Monticello Nuclear Generating Plant
Docket 50-263
License No. DPR-22

Response To Request For Additional Information Related To Inservice Testing Program Relief Request PR-07 (TAC No. MC1955)

MONTICELLO NUCLEAR GENERATING STATION RELIEF REQUEST NUMBER: PR-07

Figure 1

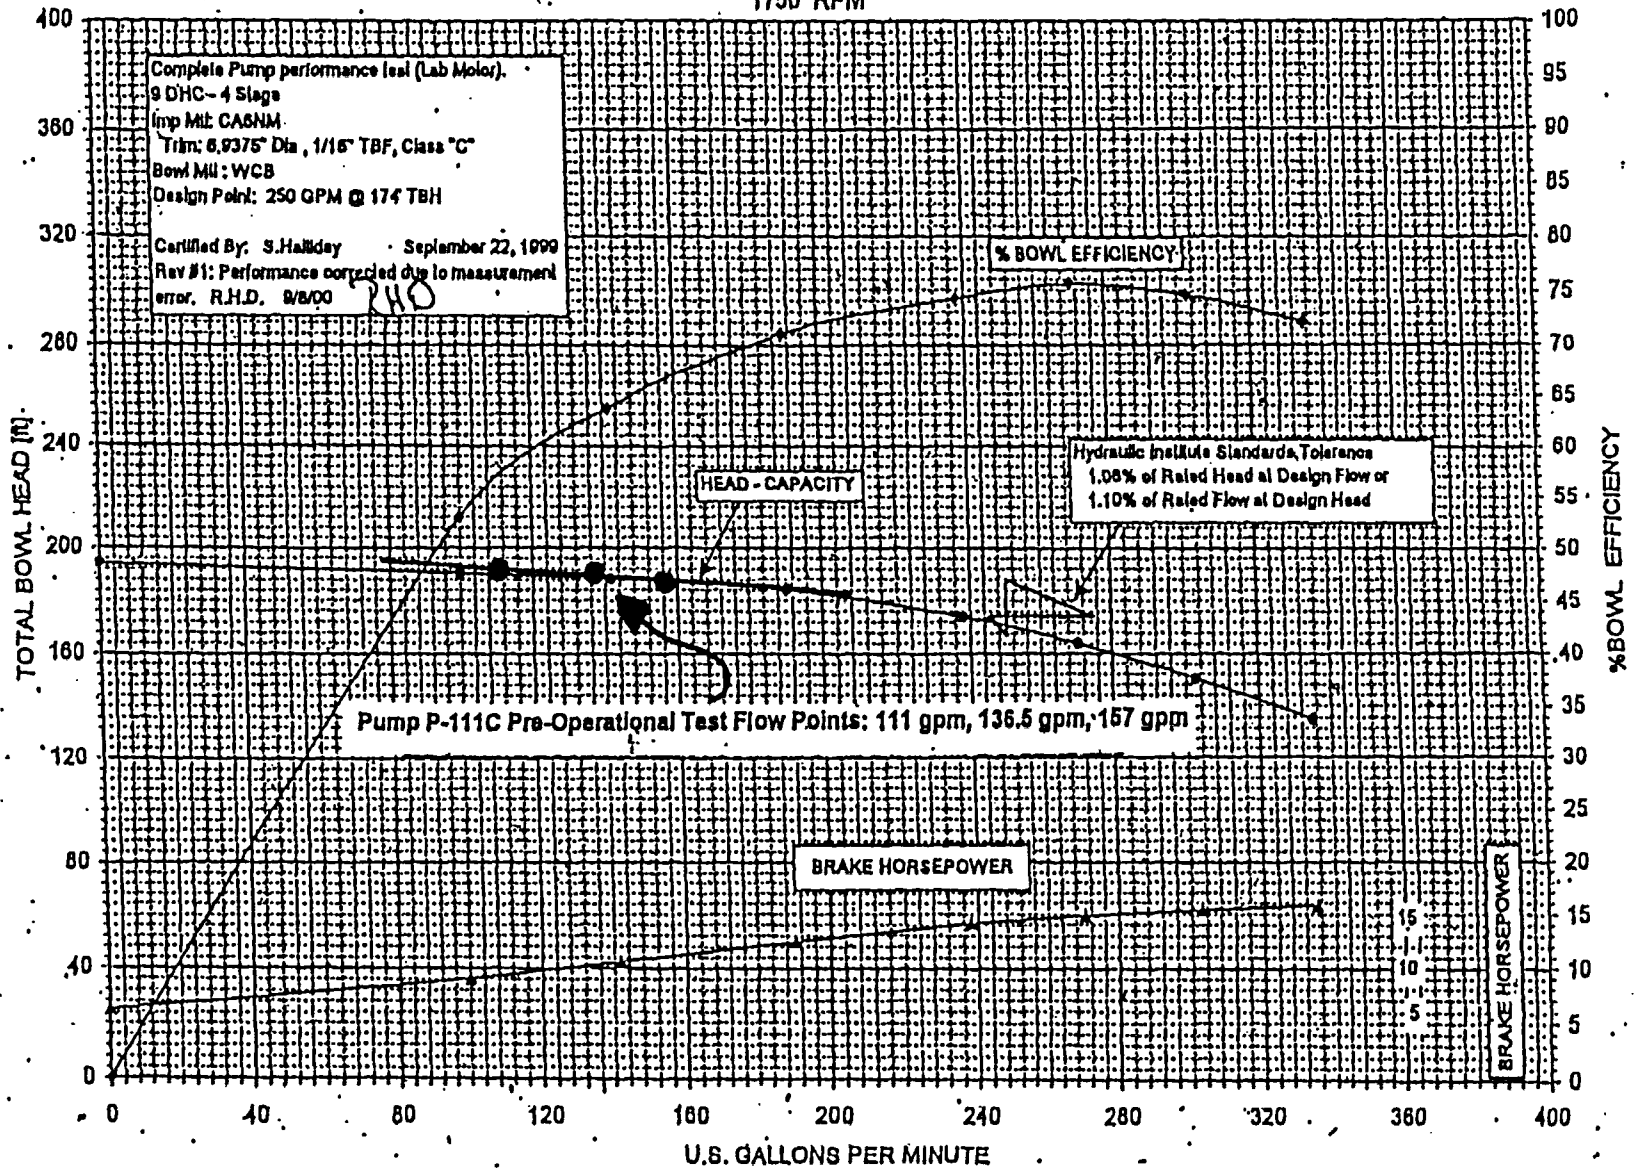
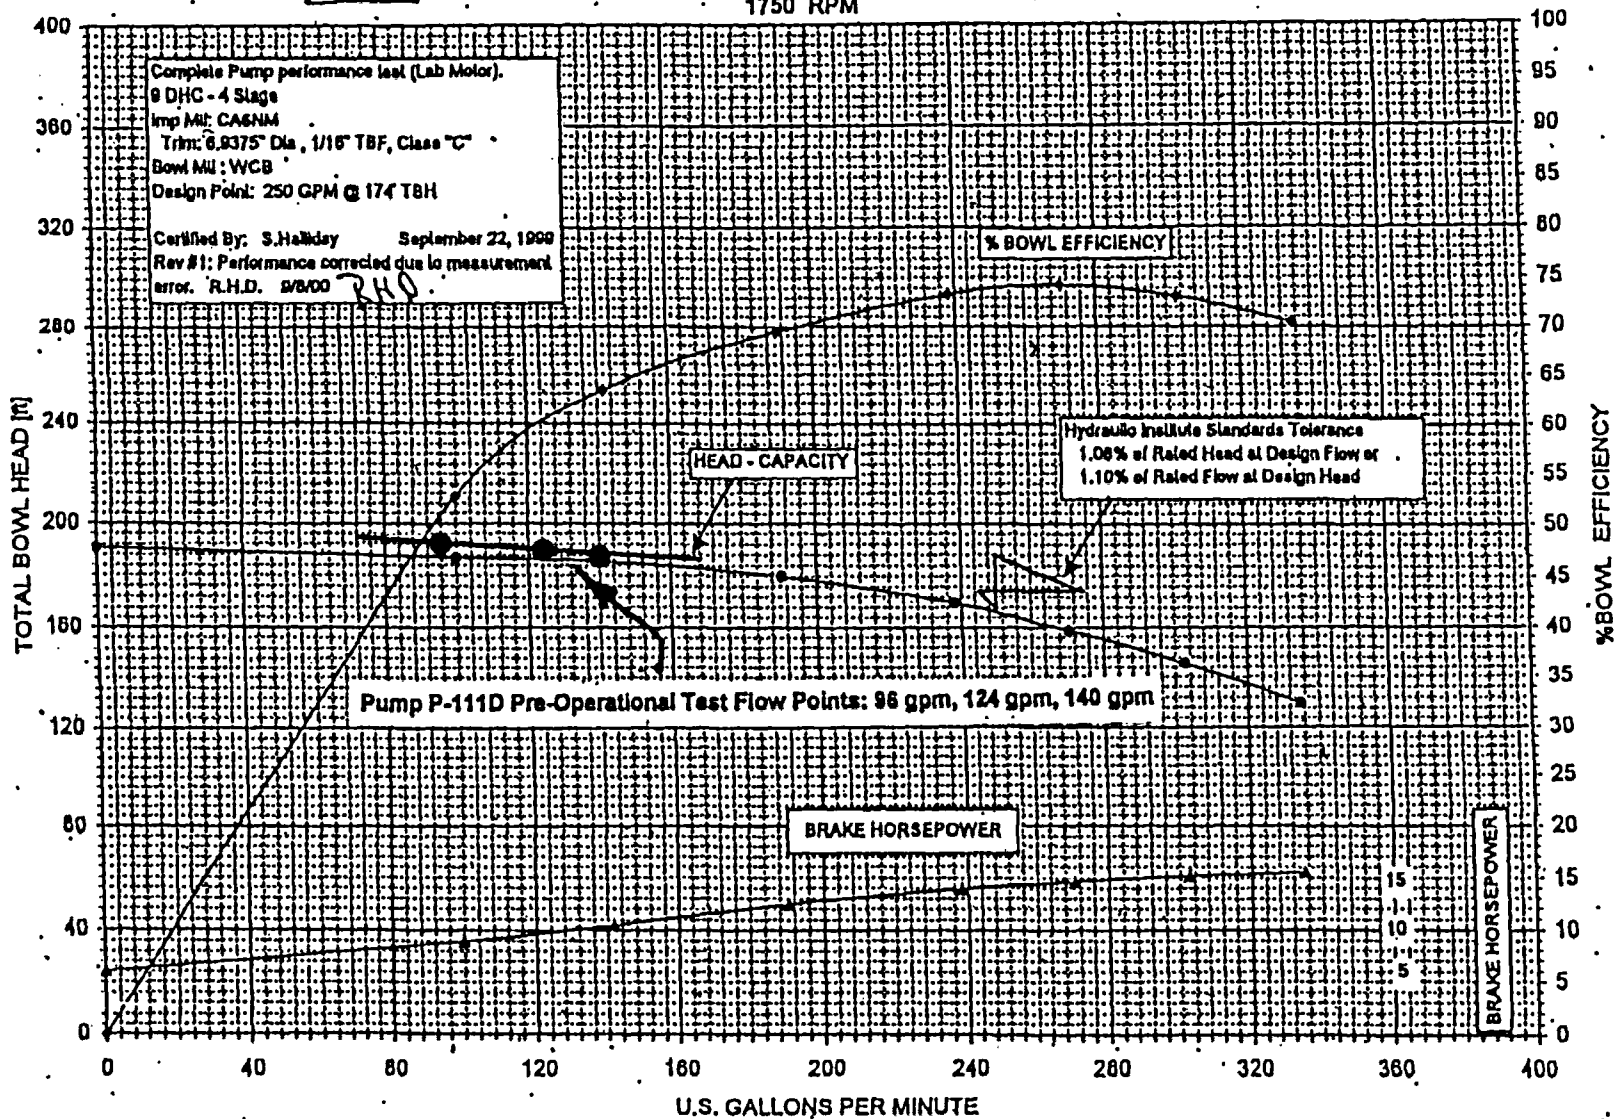
Give the details (e.g. temporary modifications of piping) of any EFT-ESW pump full-flow testing performed during pre-service or during service since the start of commercial operation. Also, provide any other full-flow data of pump shop testing provided by the manufacturer.

The pre-operational testing procedures used for acceptance of the two pumps are provided in Enclosure 5. The full-flow data of pump shop testing provided by the vendor is provided in Enclosure 6. Figure 1 and Figure 2 below show the data from the pre-op acceptance test plotted against the vendor pump curves. NMC in-situ pump testing demonstrated the pumps were capable of meeting the required minimum flow requirements for their intended service in design basis accident conditions.

Figure 3

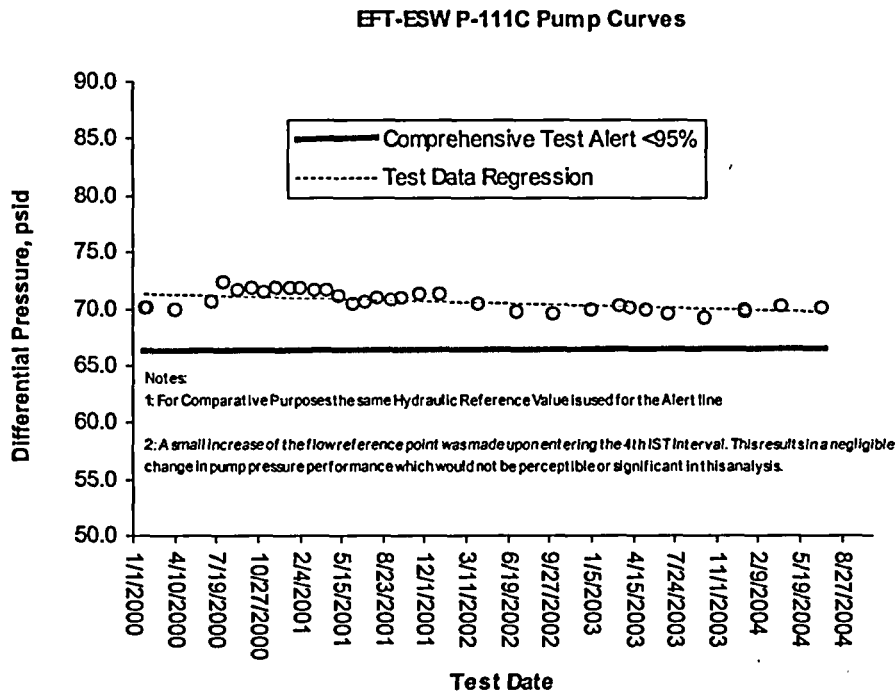
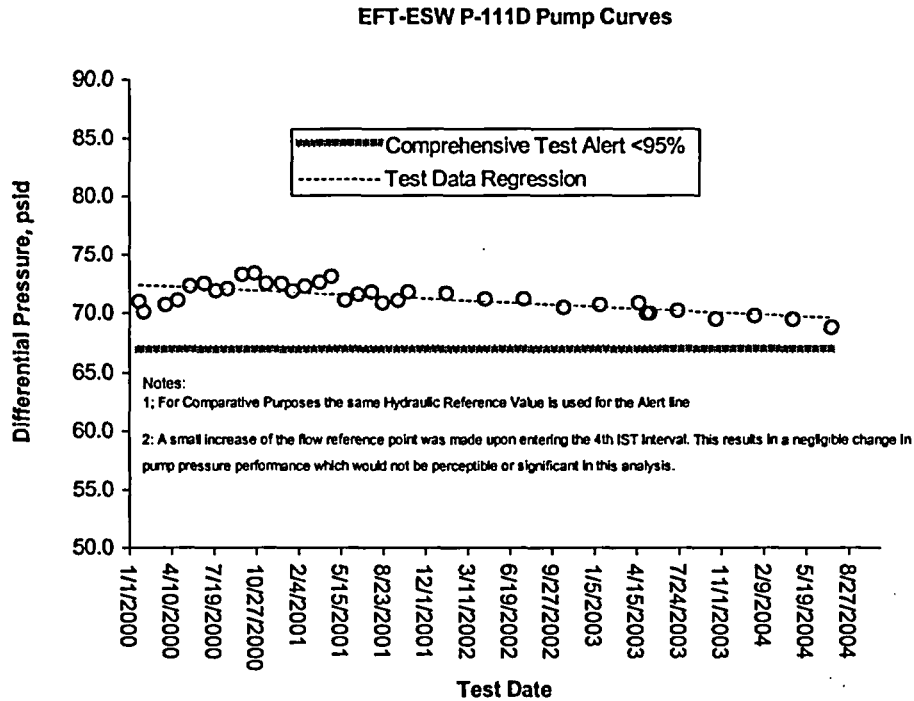
The acceptance criteria of Table ISTB 5.2.3-1, "Comprehensive Test Hydraulic Acceptance Criteria," of the ASME OM Code specifies the acceptable, alert, and required action ranges required for CPT at the pump design flow. Justify the acceptability of using these acceptance criteria for pump tests at a lower flow rate. Alternatively, justify how operation at the lower flow confirms the capability of the pump to perform as required under design flow conditions or how it meets the intent of the CPT.

when the pumps were installed (Figure 1 and Figure 2) show the pump curves closely correlate to the vendor curves in the area of operation by NMC. Figure 3 and Figure 4 provide a trend history of the pumps since installation in year 2000. Linear regression through the trend data for both pumps show the present ability to monitor the pumps for degradation during Quarterly testing, which is satisfactory. Since these pumps are not in continuous operation, a gradual, decline in pump performance is evident, as would be expected from intermittent operation. Testing at the current flow points confirms the capability of the pump to perform as required under the design basis condition for the system, as detailed in Table 1.
